SAFETY ASSESSMENT

Invercargill 66 KV Poles

For Powernet

January 2025

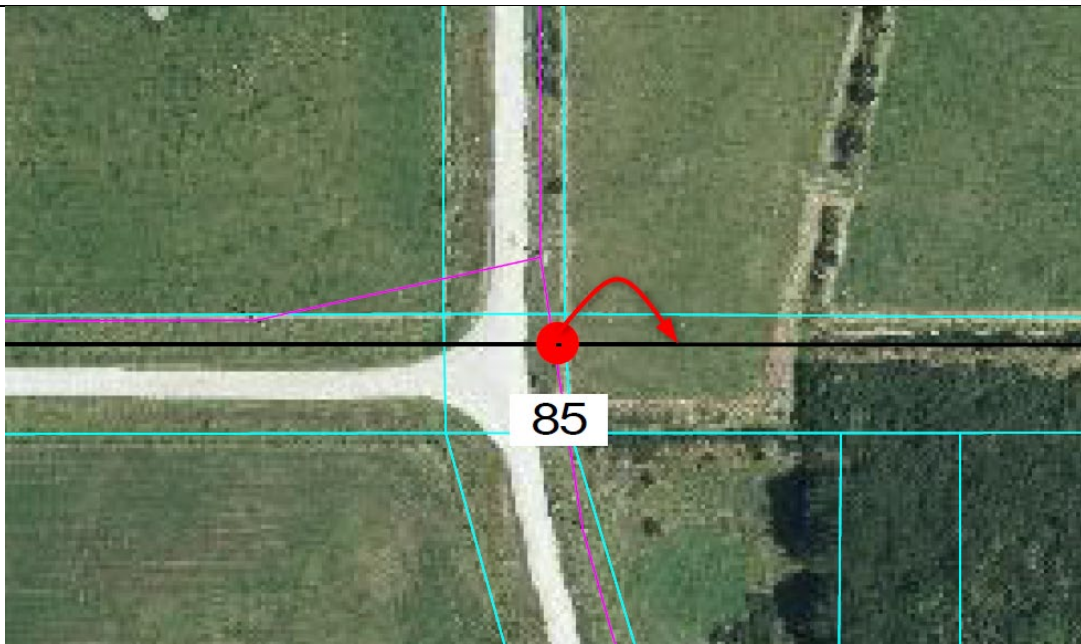
25. The waratahs for Pole 43 and 44 could not be found but the plan indicates pole 43 is closer to the carriageway due to the shape of the property boundary. Given the high number of loss of control crashes reported on the curve that result in vehicles leaving the carriageway, it is considered that this pole could be at risk of being struck by out of control vehicles.

26. ICC should be advised of the high crash rate in the area since they may want to address the underlying safety problems that are evident on the curve. Depending on what solutions the ICC propose, a crash barrier should be considered to be erected around pole 43.

27. Pole 44 should be located as close to the property boundary as possible. The area near the boundary is raised and would redirect any out of control vehicle away from the pole as well as being outside the clearzone.

- Locate the new poles 33 to 42 as close as possible to the property boundary.
- Consider providing a barrier around pole 43.
- Ensure Pole 44 is located close to the property boundary and behind the soil mounds.
- Erect poles 47 to 50 on the southern side of the swale drain.
- Erect poles 51 to 56 as close as possible to the boundary.

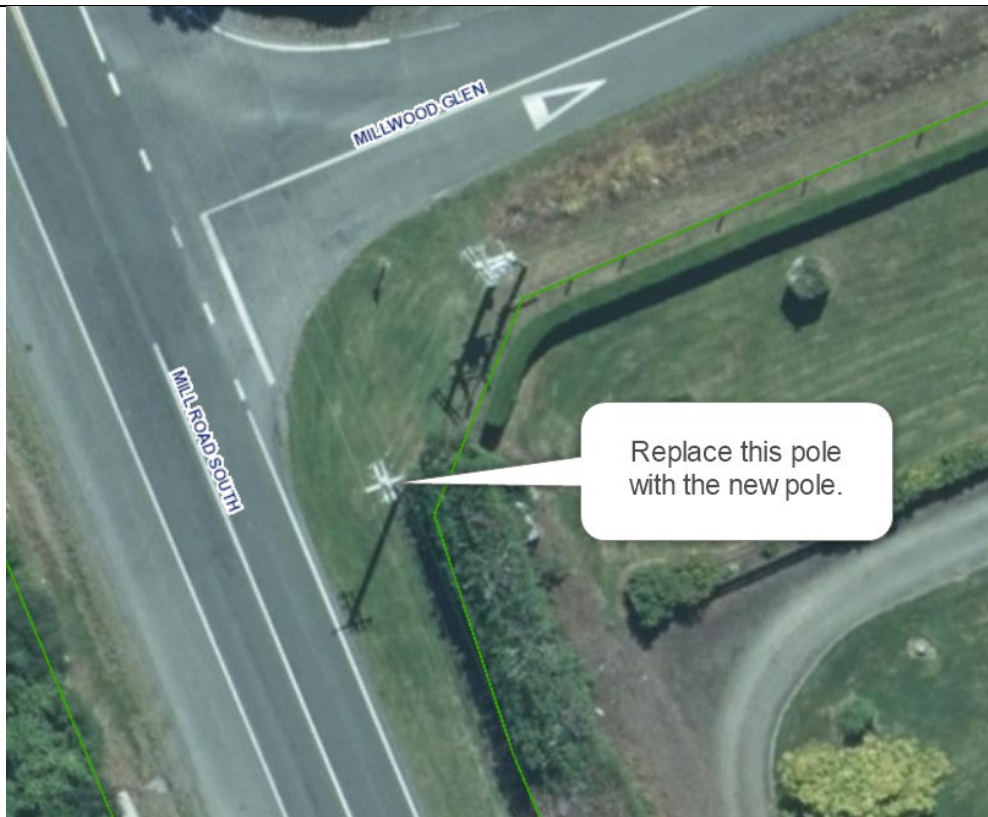
51. There is a private road between 109 and 119 Mill Road and a second cul-de-sac called Millwood Glen. Both have similar designs for the intersections with Mill Road. Poles 143 and 147 are shown in similar positions on these intersections. It is considered that these poles would be exposed to being struck by turning vehicles in their proposed locations as well restricting visibility to the left from the limit line or the side road.

52. Note also the streetlights that will need to be considered.

- Ensure the poles are erected as close as possible to the property boundary.
- Change the locations of poles 143 and 147 as shown.
- Relocate pole 150.

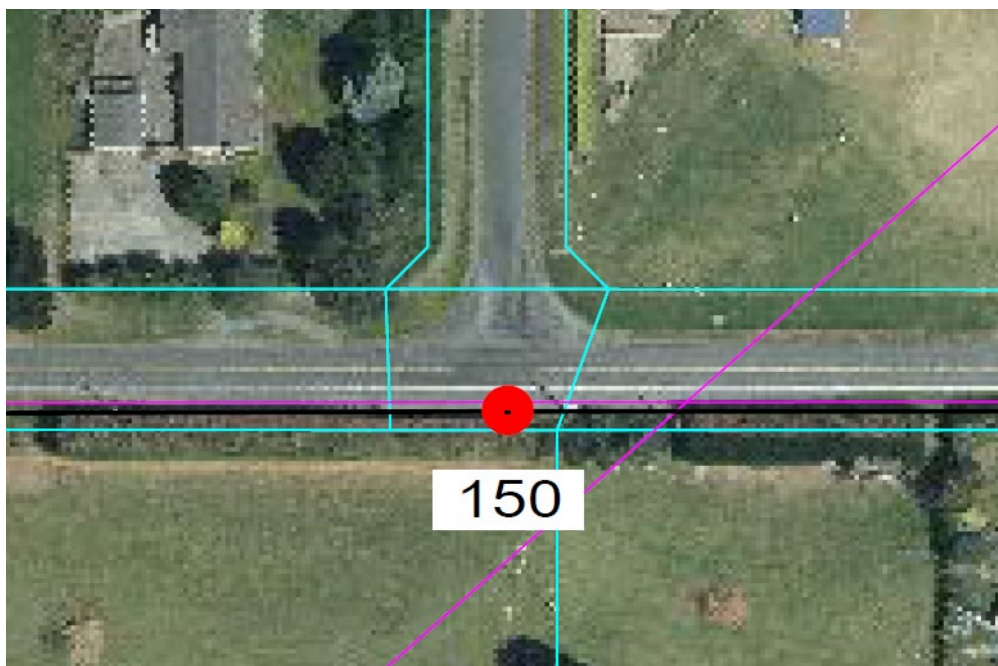
53. The second photograph shows Millwood Glen and it is considered that this shows a reasonable revised solution for the intersections. The boundaries are splayed to allow for the sight triangles and the wooden pole on the right is an appropriate location for the new pole to follow the boundary without causing aerial trespass. It is less likely to cause a visibility obstruction than if it was erected where the waratah is shown and will be less likely to be struck by a vehicle manoeuvring at the intersection.
54. It is considered that poles 143 and 147 should be located as shown in the aerial photo below with the side road pole to follow the splayed boundary. Note that streetlighting will need to be considered.
